General Electric Company
123 Eighth Avenue, San Jose, CA 95128

MFN No. 025-92
Docket No. STN 50-605
EEN-9212

Subject: **GE Responses to the Additional Items Noted in the Draft SER for Chapter 7**

Figure 2.2.7a REACTOR PROTECTION SYSTEM

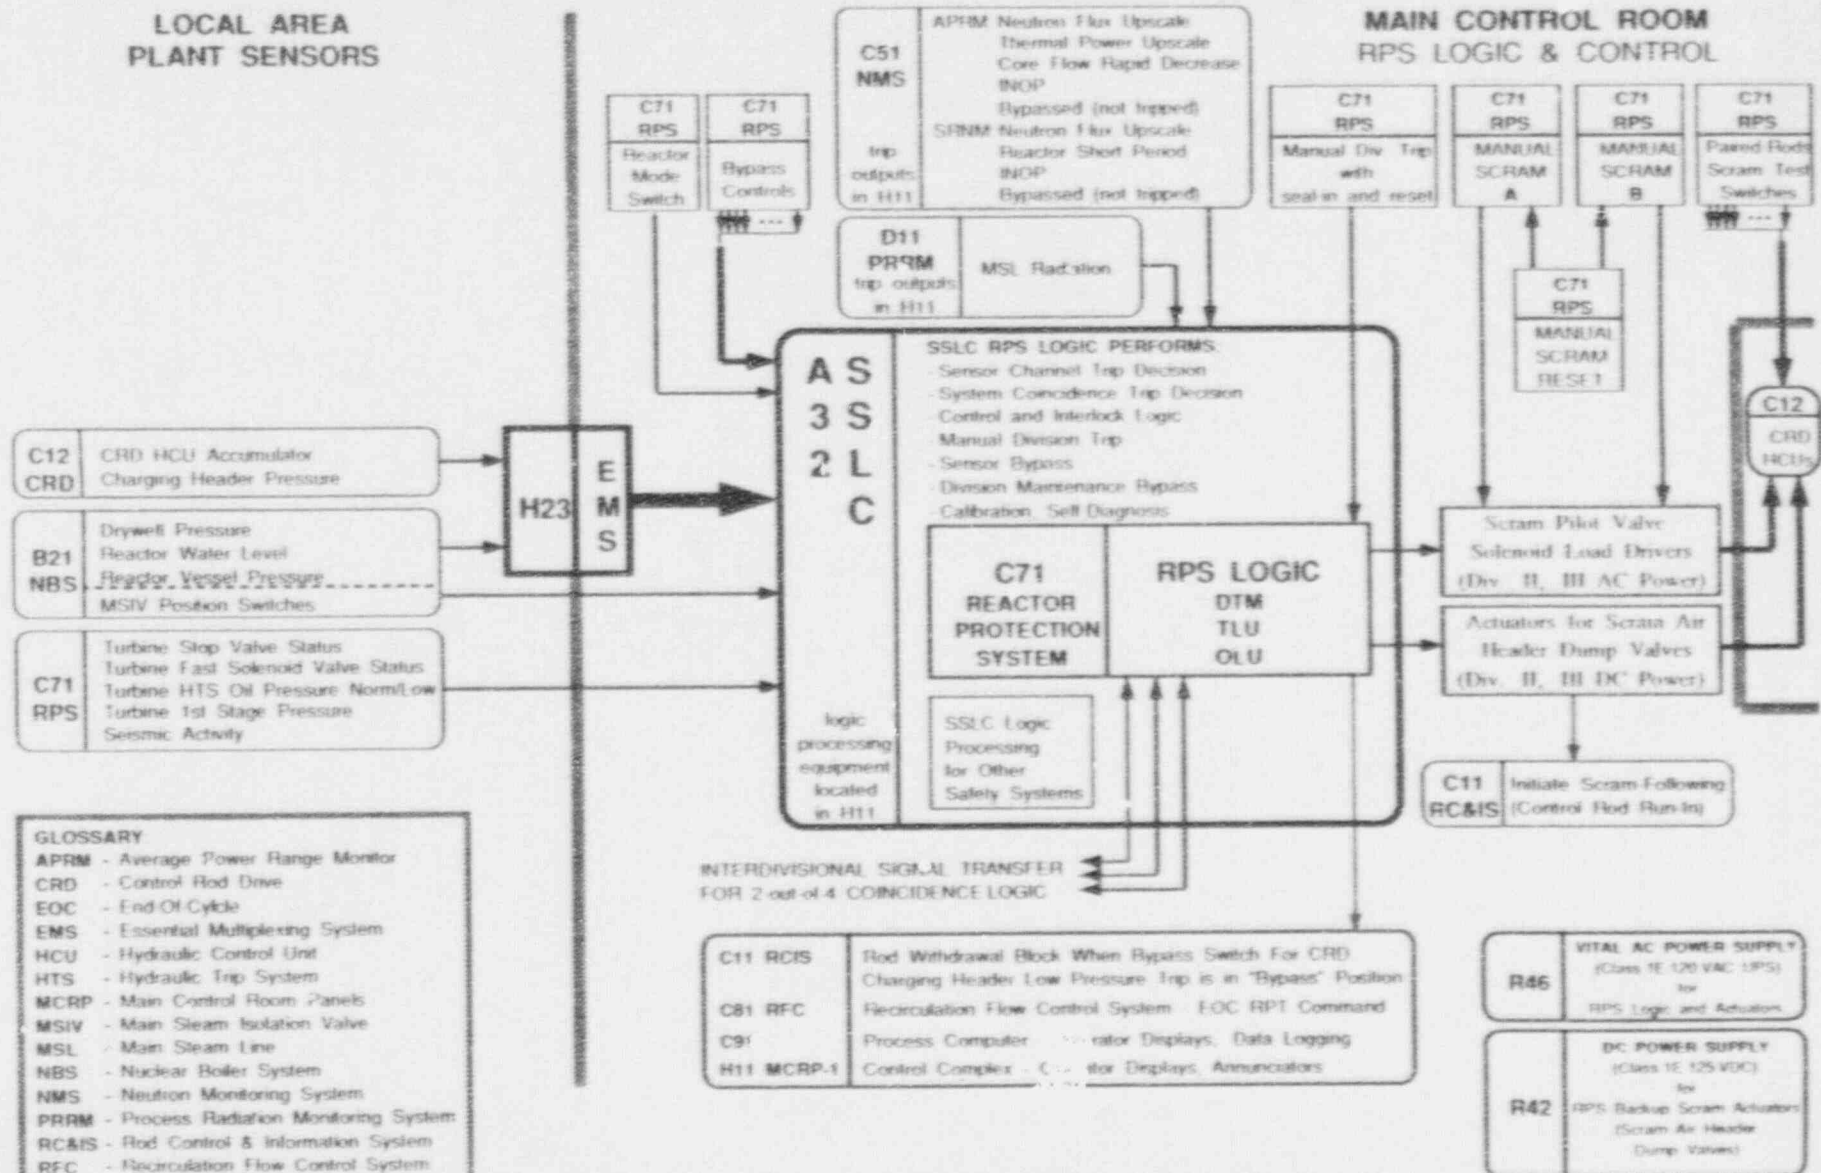
As shown in Figure 2.2.7a, the RPS interfaces with the neutron monitoring system (NMS), the process radiation monitoring (PRRM) system, the nuclear boiler system (NBS), the control rod drive (CRD) system, the rod control and information system (RC&IS), the recirculation flow control (RFC) system, the process computer system and with other plant systems and equipment. RPS components and equipment are separated or segregated from process control system sensors, circuits and functions such as to minimize control and protection system interactions. Any necessary interlocks from the RPS to control systems are through isolation devices.
